Supporto M72 Chius. lat. M72 ECL 11.25

SUPPORT

S-01002-03

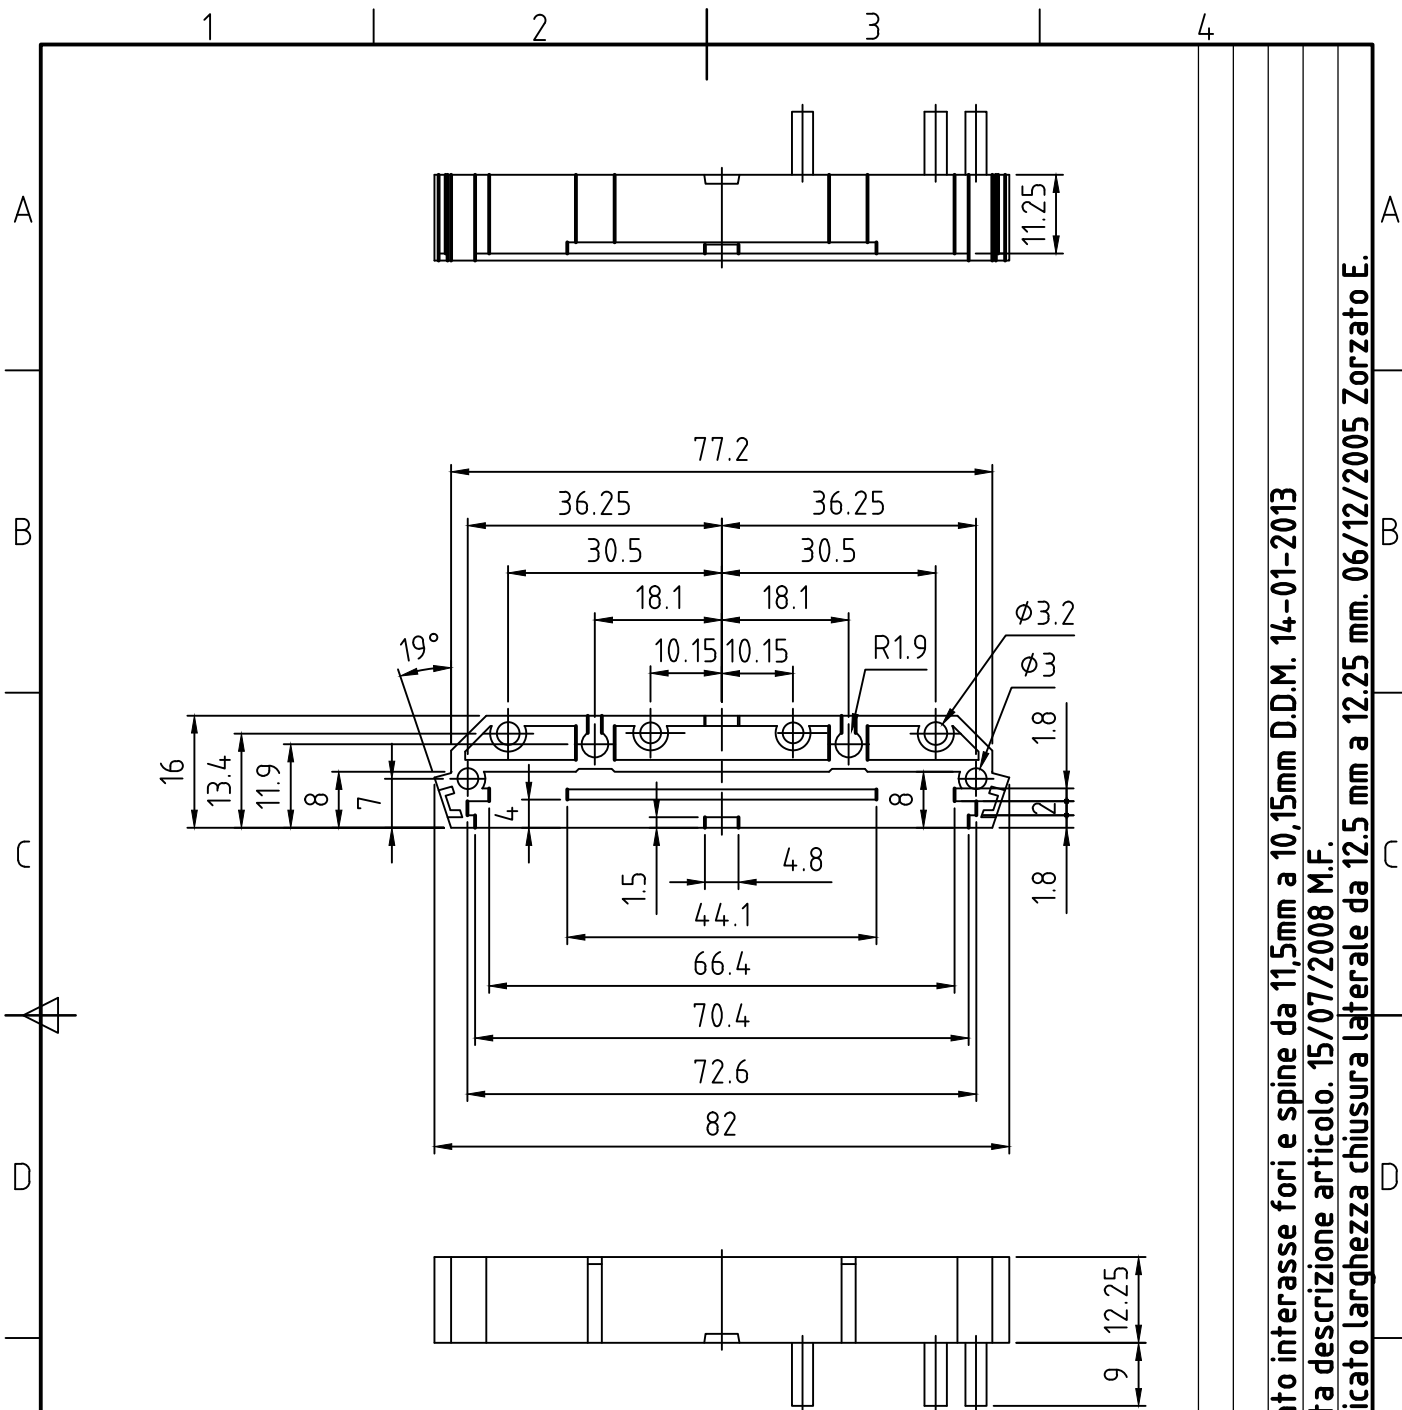
Aggiornato interasse fori e spine da 11,5mm a 10,15mm D.D.M. 14-01-2013

Modificata descrizione articolo. 15/07/2008 M.F.

01 Modificato larghezza chiusura laterale da 12,5 mm a 12,25 mm. 06/12/2005 Zorzato E.
